Microsemi Corporation

Product/Process Change Notification No: PCN1506

Subject: Transition from Corner Gate Mold (CGM) to Pin Gate Mold (PGM) process for A3PE3000, APA1000, and APA750 devices in FG896/FGG896 packages at Amkor Korea (ATK4)

Figure 1 Comparison of FGG896 packaged devices that use the Corner Gate Mold (left and center), and the Pin Gate Mold (right)

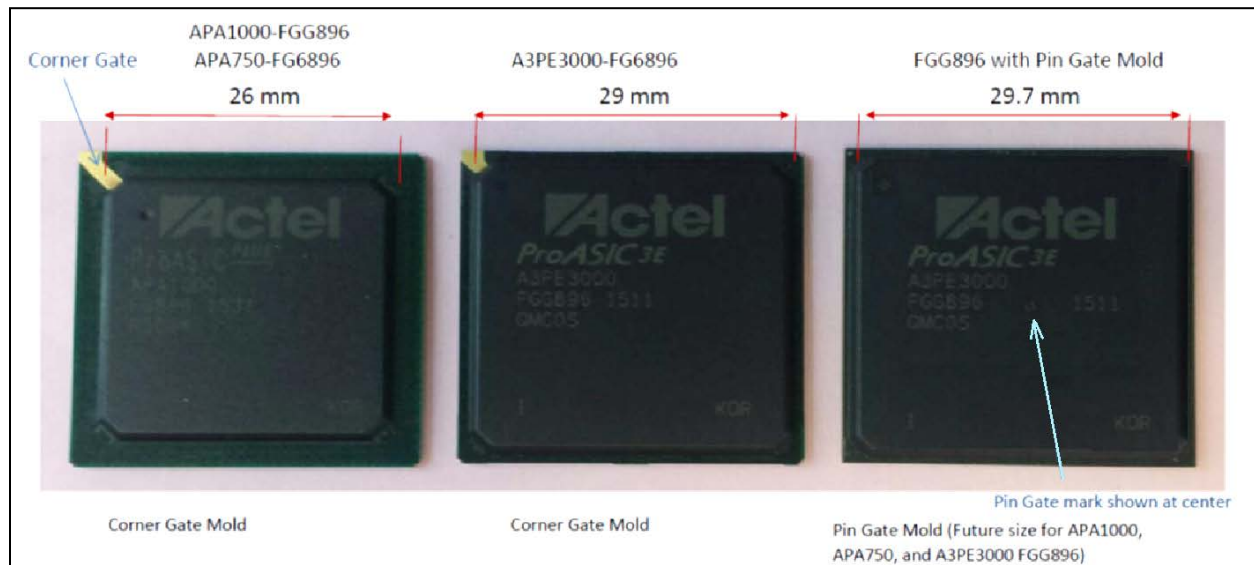
The package mold cap will change slightly and the lead-free solder ball will use SAC305 instead of SAC405.

The slight increase in the mold compound coverage will not affect the fit and function as defined in the product data sheets. There is no change to the total package thickness and to the X and Y dimensions of the substrates. Refer to [Figure 1](#) for the description of body size.

The current packages have relatively large metallized area (mold gate) on the pin in one corner.

The packages processed with PGM have a dimple at the center of the package. Refer to [Figure 1](#).
